Burlington Design Advisory Board

Design Advisory Board

Tuesday, August 12, 2025, 5:30 PM

ZP-25-325; 322-324 St. Paul Street (RC, Ward 6) Champlain Housing Trust / Taryn Barrett

SITE LAYOUT AND GRADING PLAN

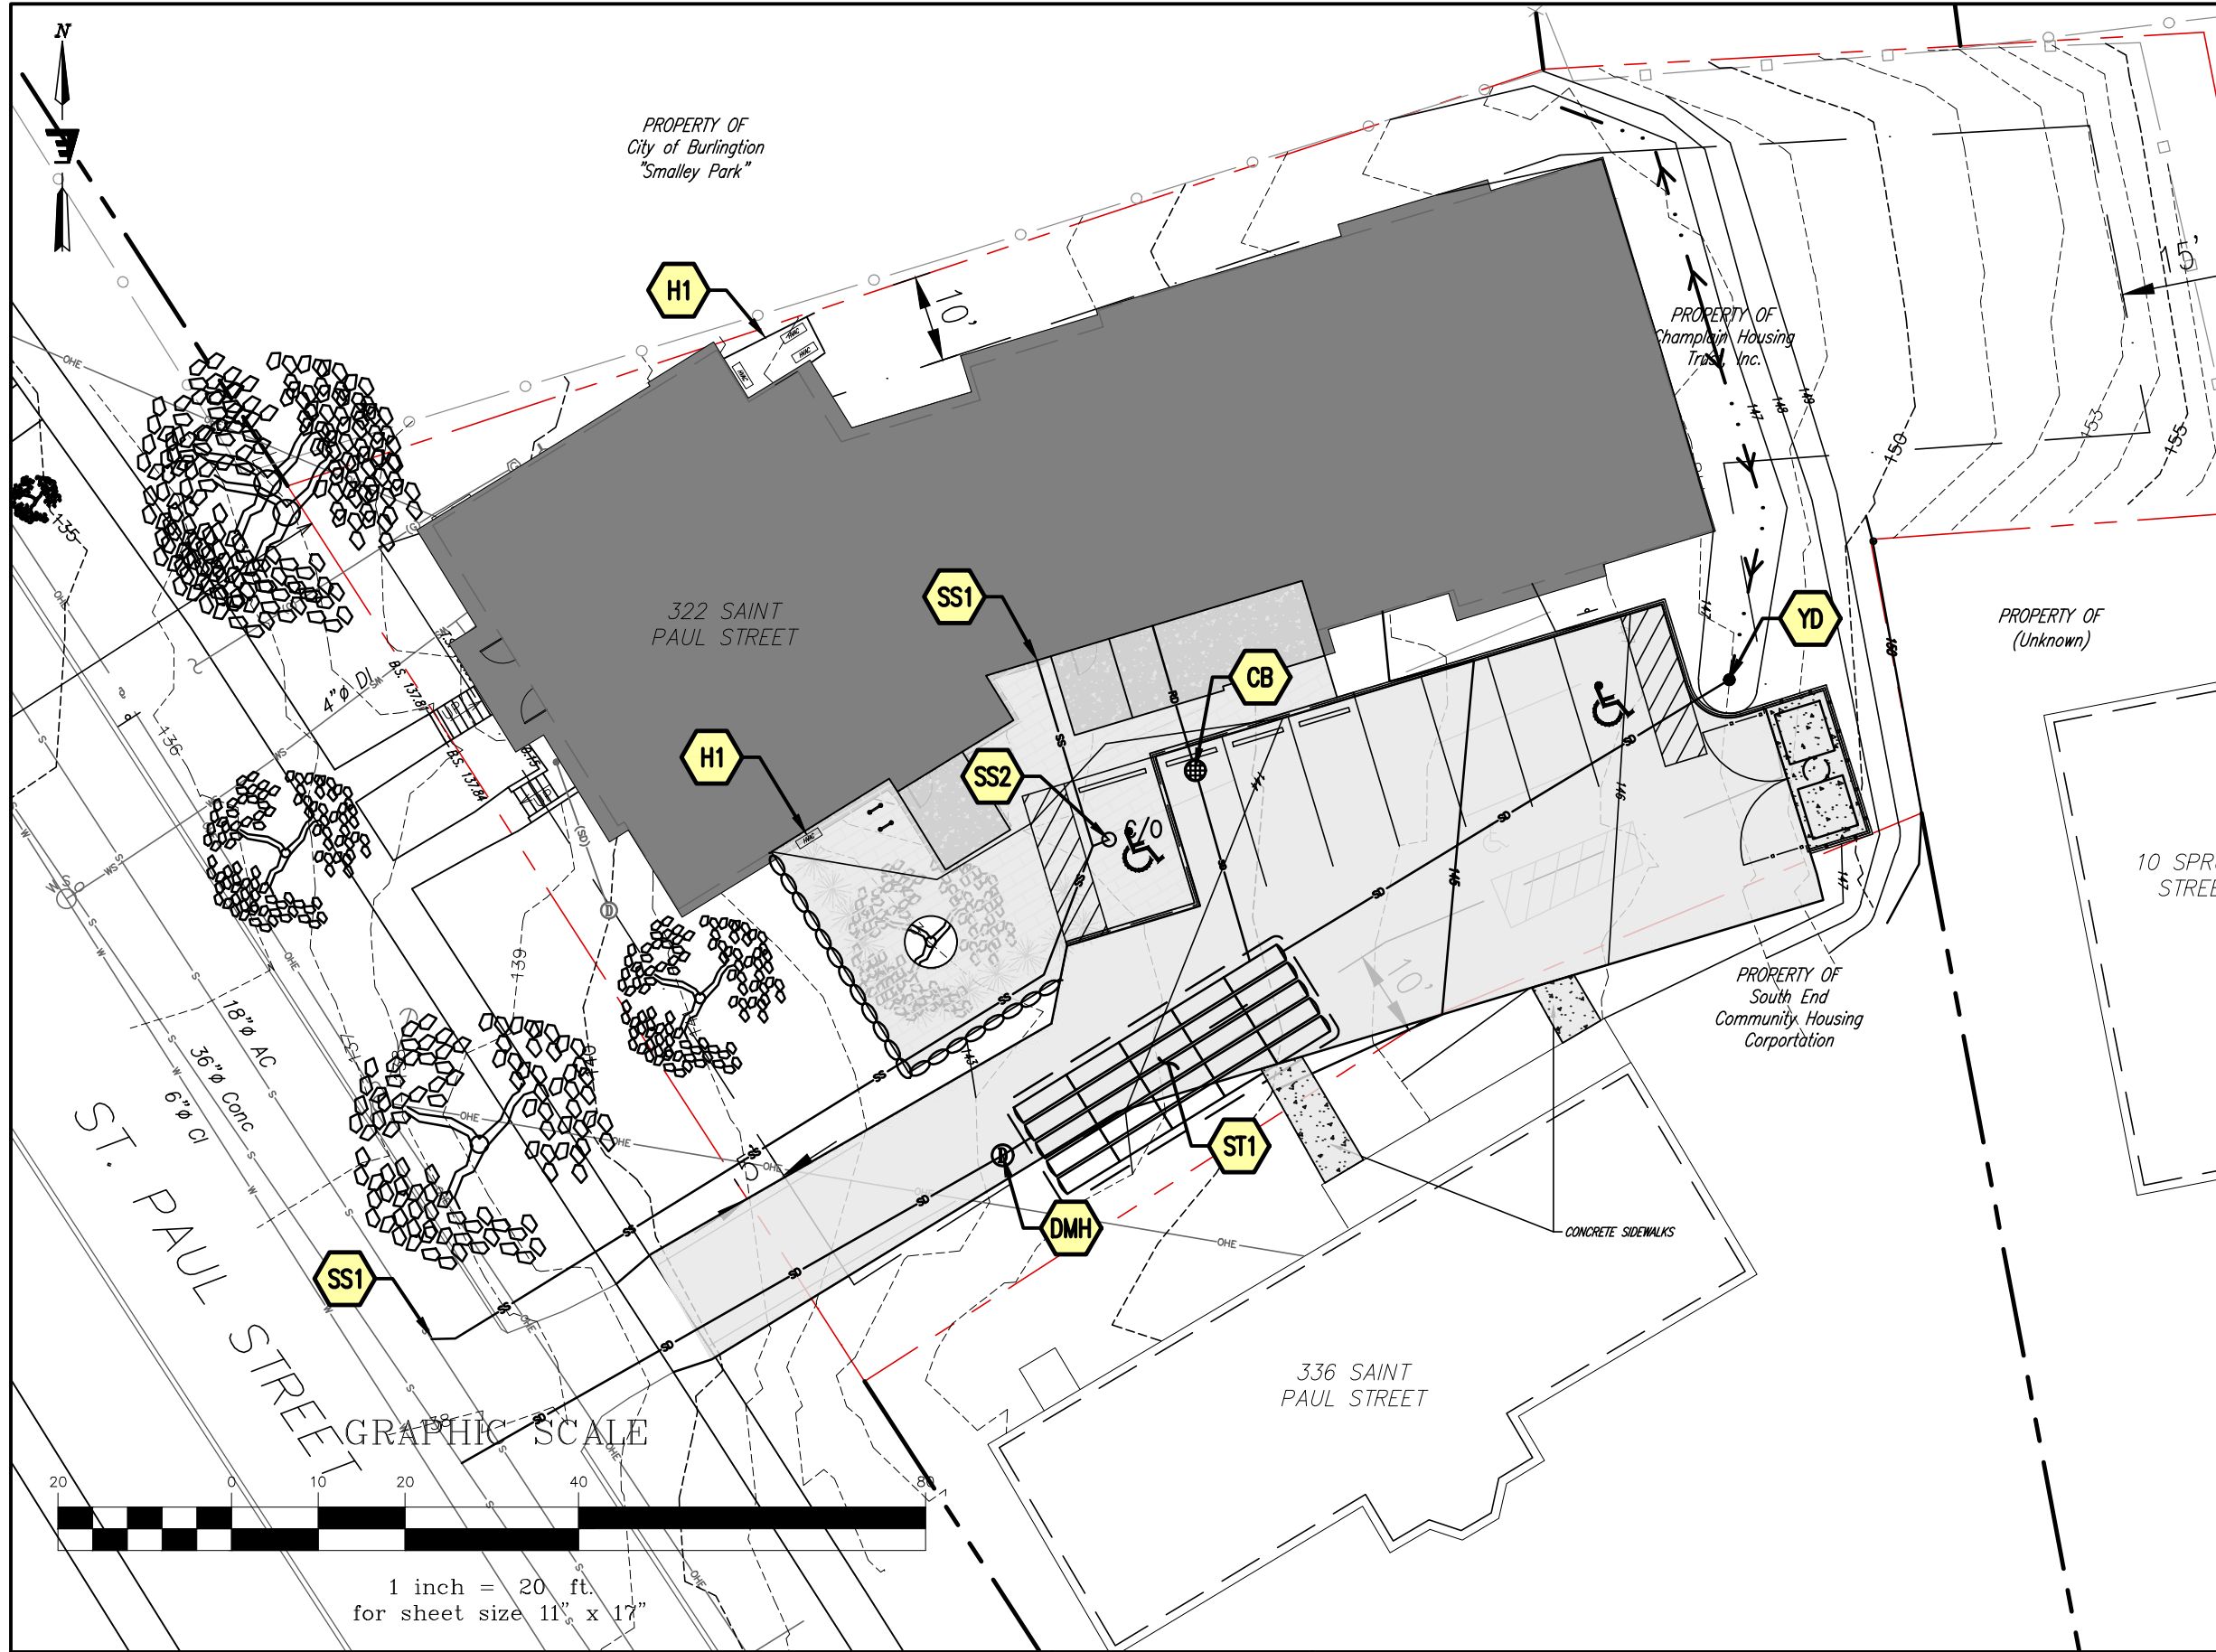
The site plans depict mechanical unit and dumpster locations. Most are acceptably placed. The heat pumps near the northeast corner of the existing building appear to sit within the side yard setback and will need to be relocated to be at least 5' from the side property line.

2. Details for the dumpster enclosure and concrete block wall.
3. Revised site plan that relocates proposed mechanical units out of the minimum required 5' side and rear yard setbacks.

DUMPSTER ENCLOSURE DETAIL
NOT TO SCALE 4

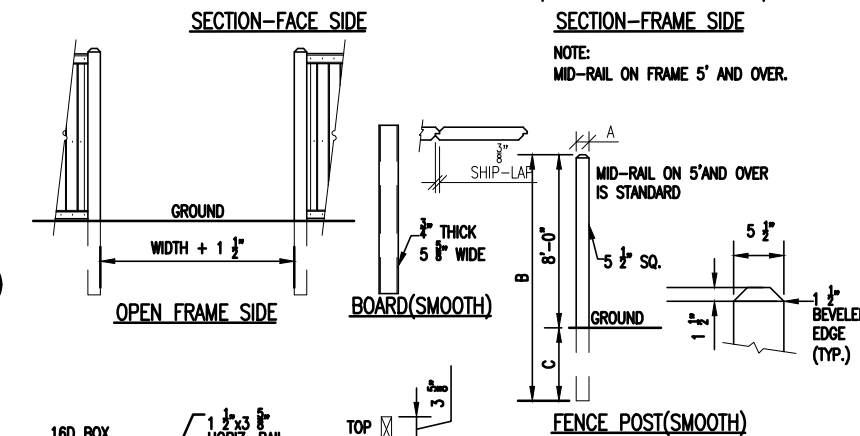
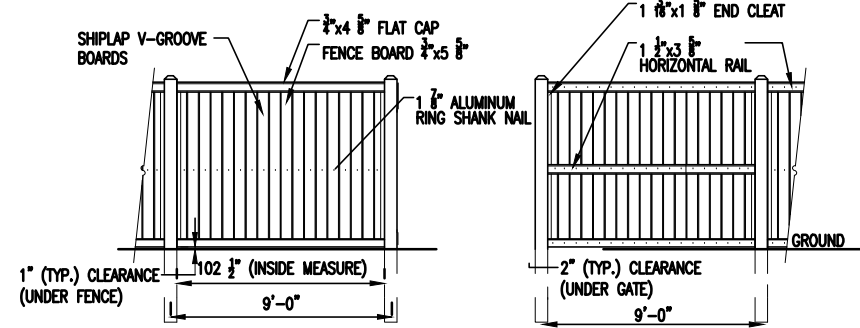
New fencing is limited to the enclosure for the dumpsters. The site plan notes it will be cedar but nothing else. A detail is needed.

FREE STANDING SEGMENTAL BLOCK WALL 3

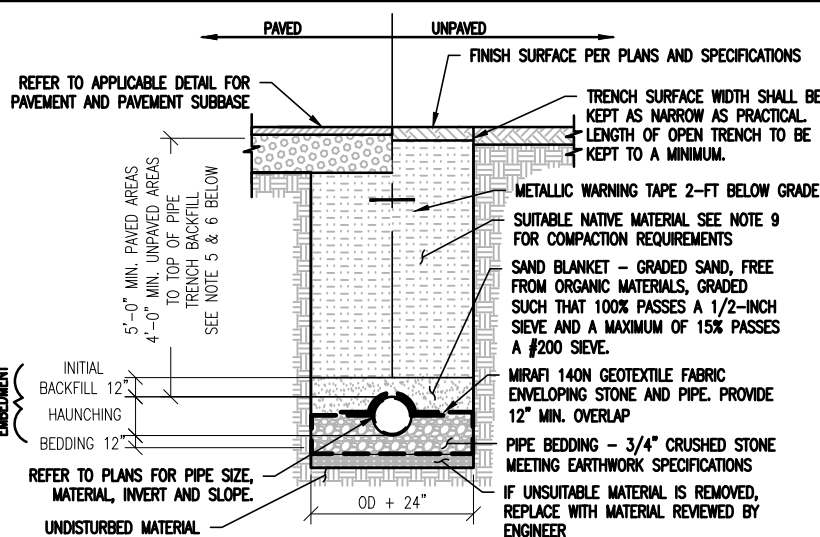
A concrete block wall of up to 30" will be constructed along the south and west borders of the proposed patio. As with the dumpster enclosure, a detail is needed.

**PROPOSED
CONDITIONS
PLAN**

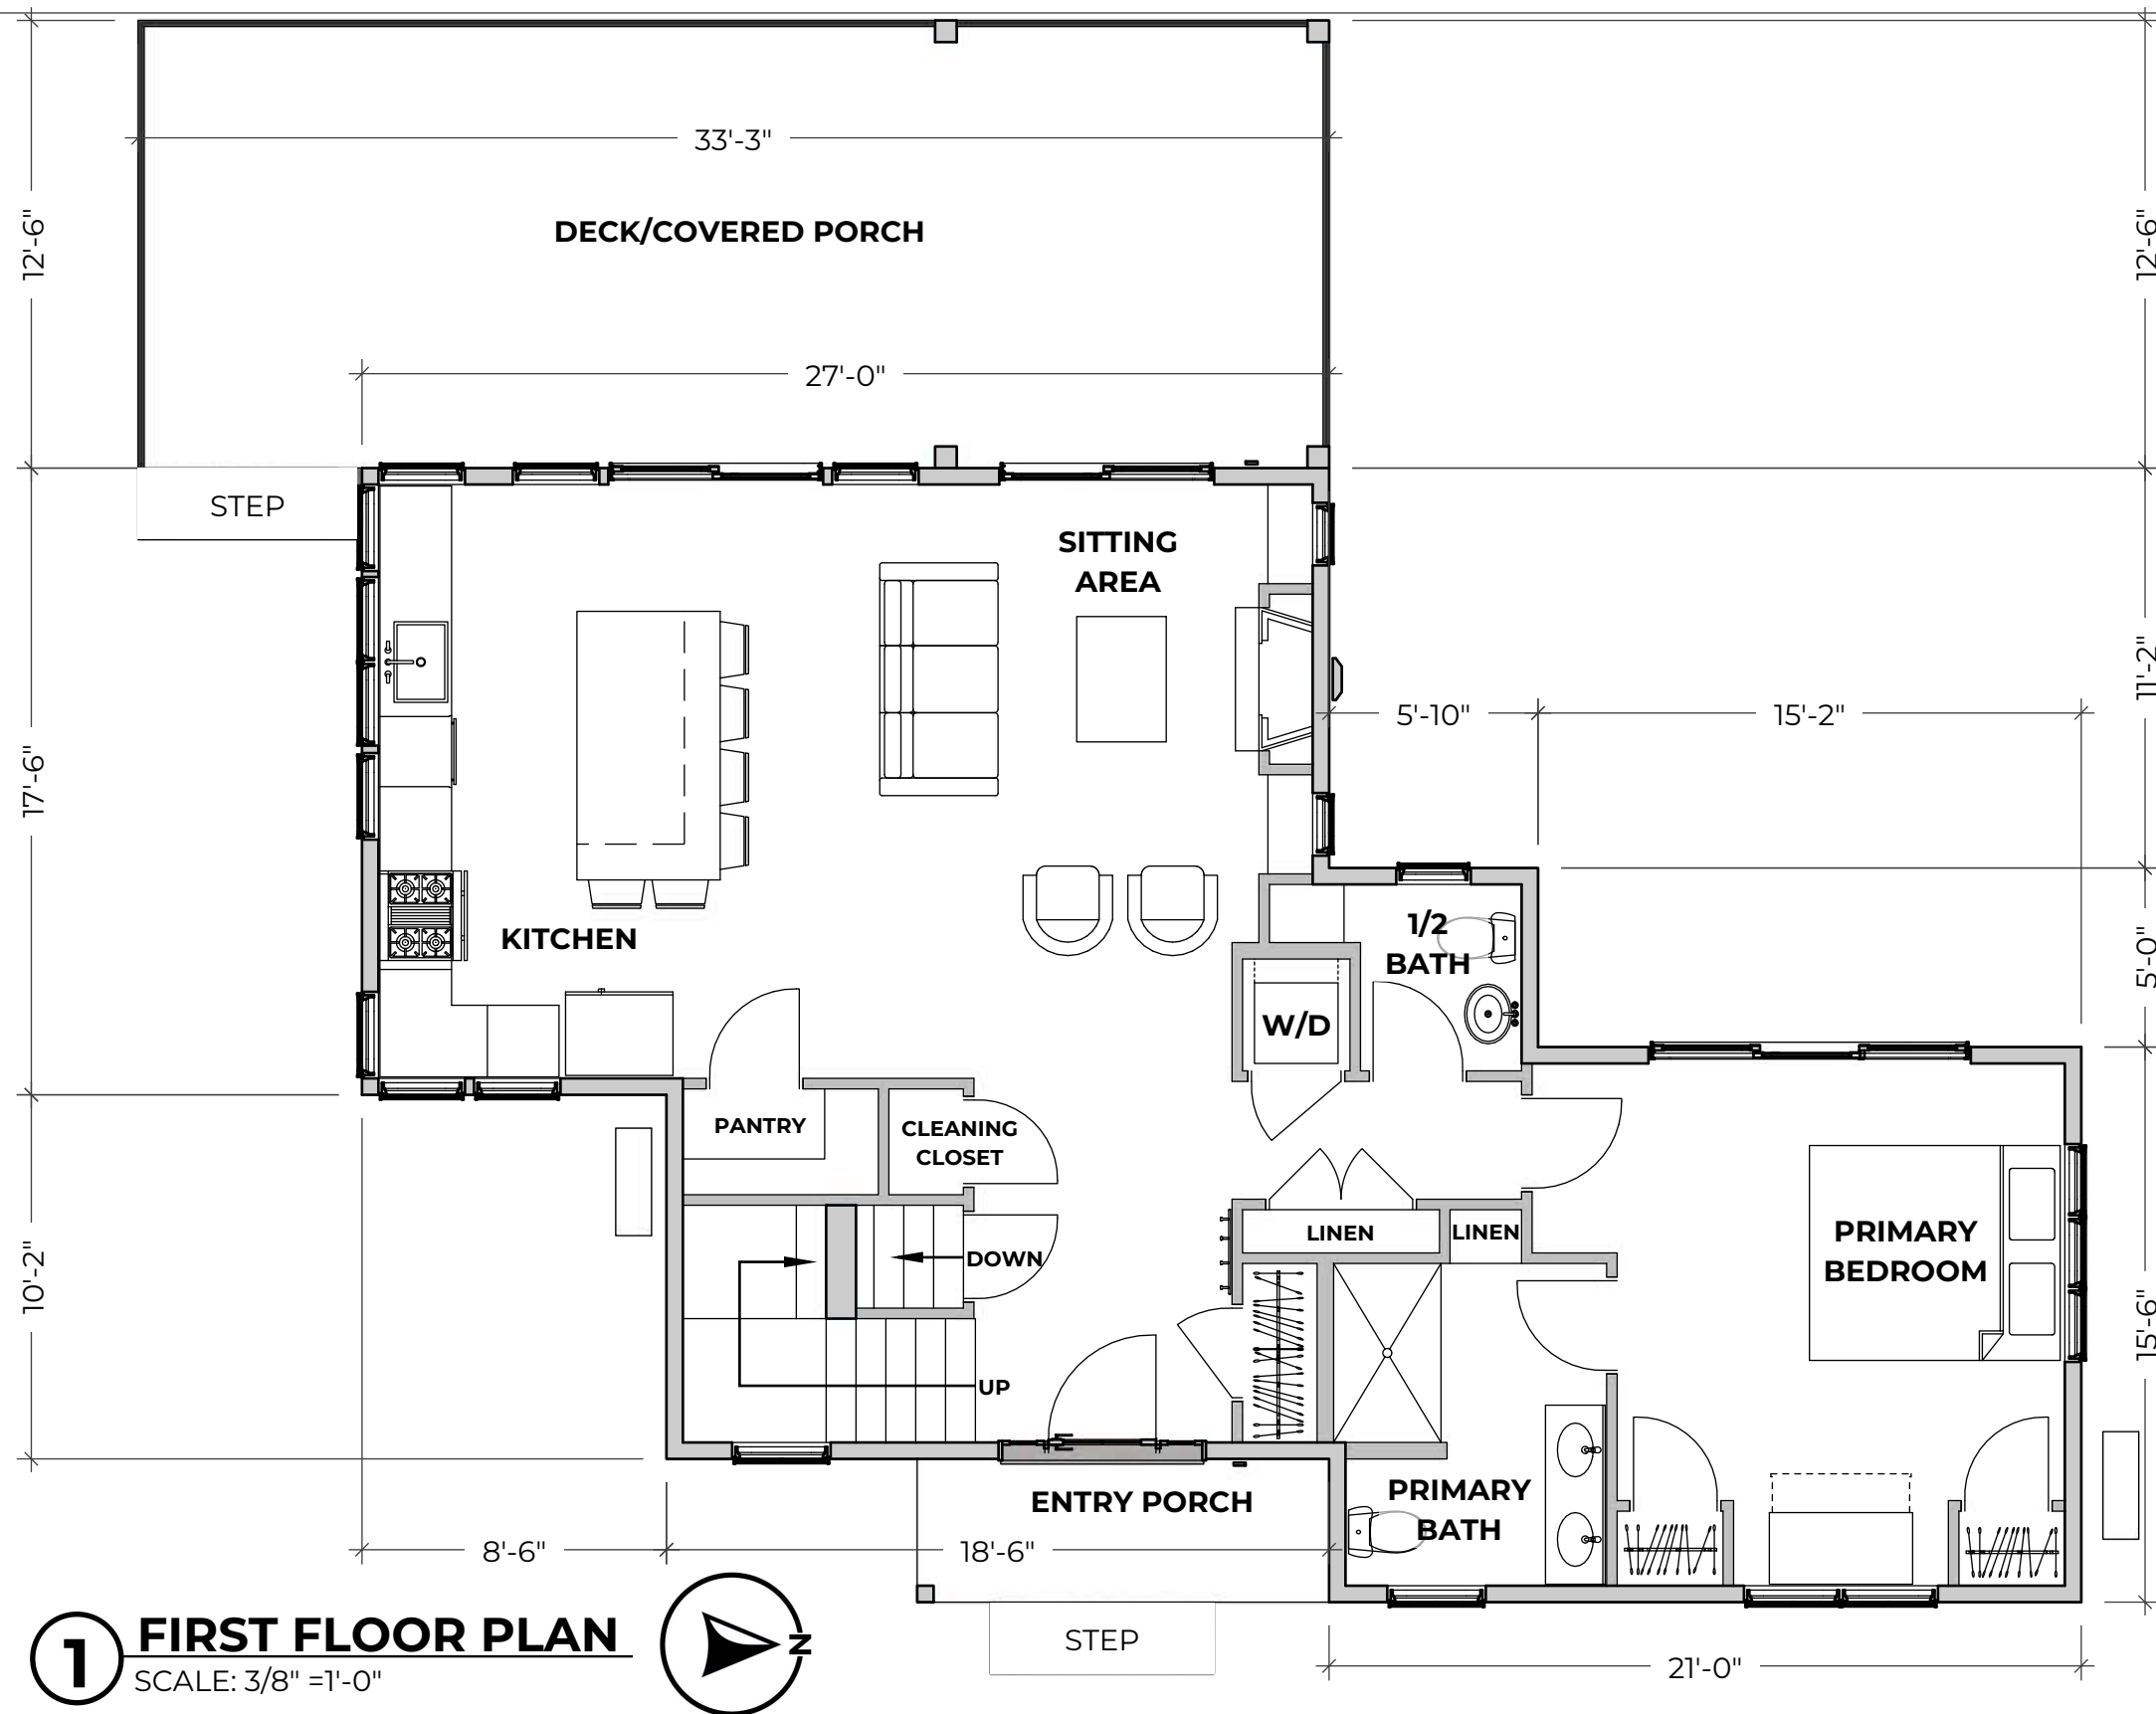
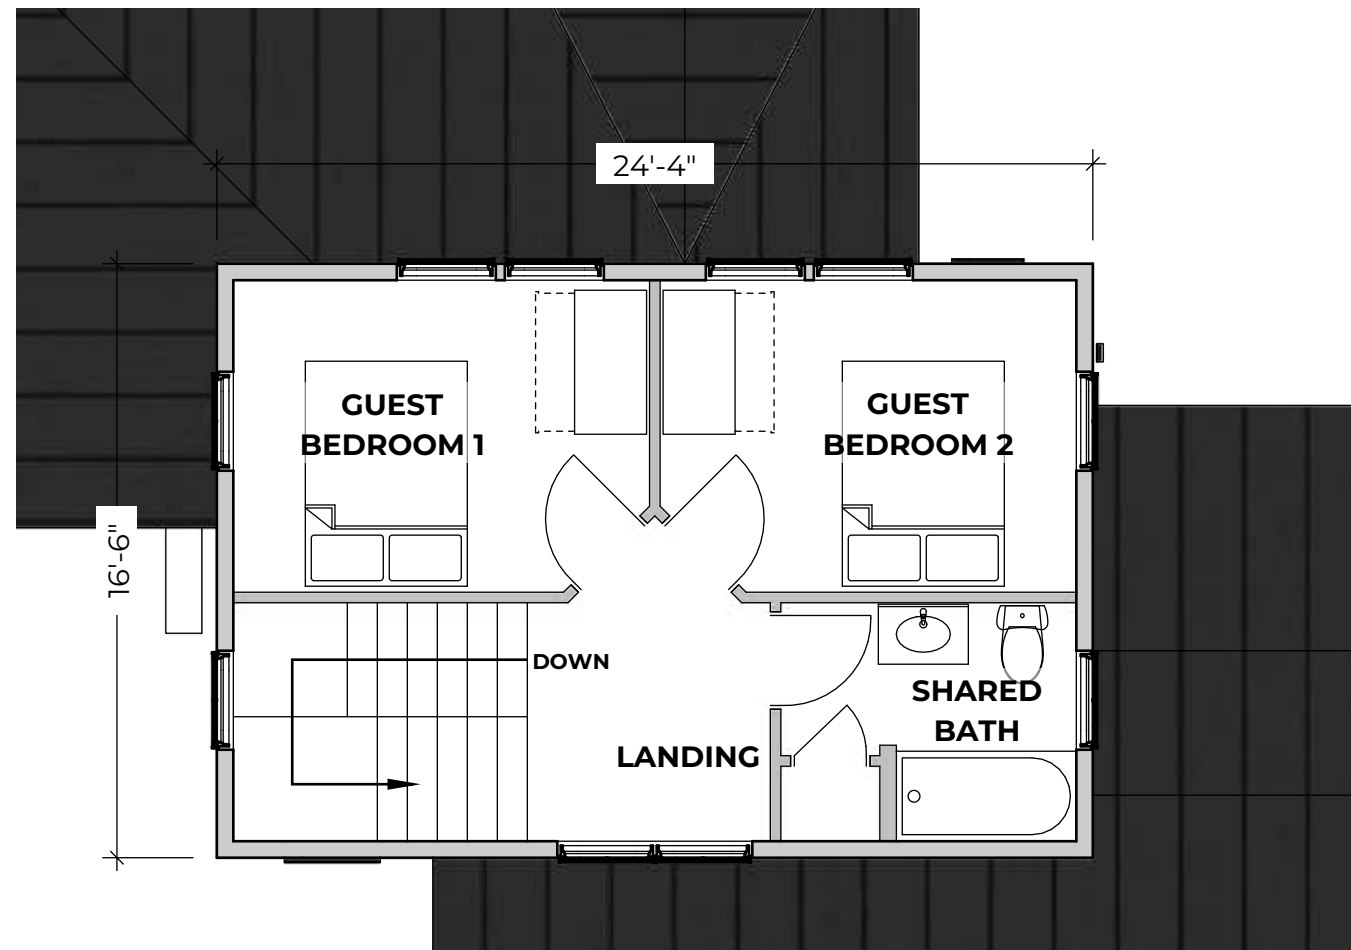
to construction, a geotechnical analysis prepared and stamped by a professional geotechnical engineer must be provided that determines the suitability of the steep slope for development. (See Plan C1.0 for Steep Slopes identification, and Plan C2.0 for proposed conditions. Engineers report is a separate attachment.)

While general topographical alterations are not proposed, a basement entry will require excavating 4' of soil on the west elevation. See Engineer's Steep Slopes Survey report and plan for transition and slope stabilization.
